#### World Forum for Harmonization of Vehicle Regulations

##### **1958 Agreement – Consideration of draft amendments to existing Regulations submitted by GRSG**

### **Proposal for Supplement 14 to Regulation No. 43 (Safety glazing)**

"Figure 1b  
"

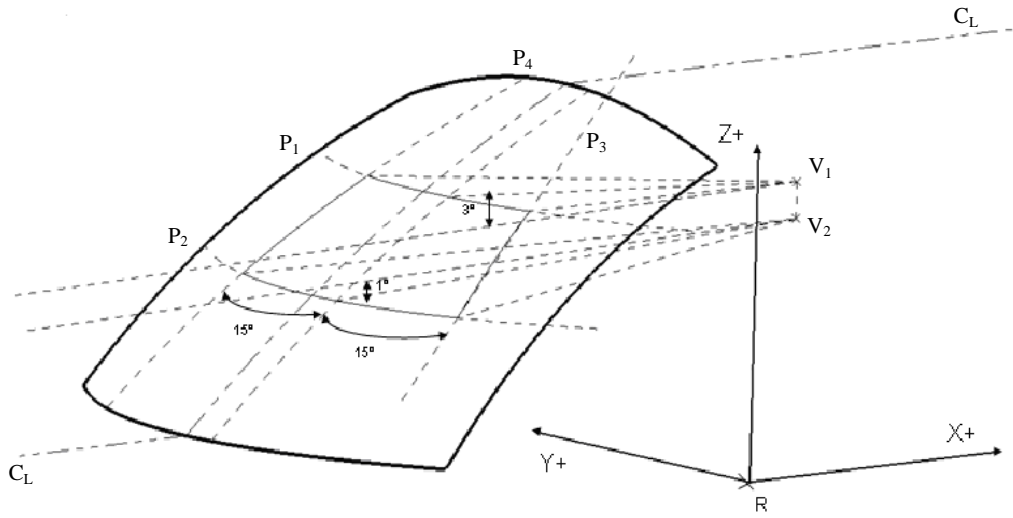
- (e) In case of a single central driving position, two planes upwards and downwards as defined in paragraphs 2.2 (a) and (b) above and two vertical plane passing through V1 and V2 and inclined at 15° to the left of the X axis (plane 3) and 15° to the right of the X axis (plane 4) (see figure 1b)."

Insert a new figure 1b, to read:
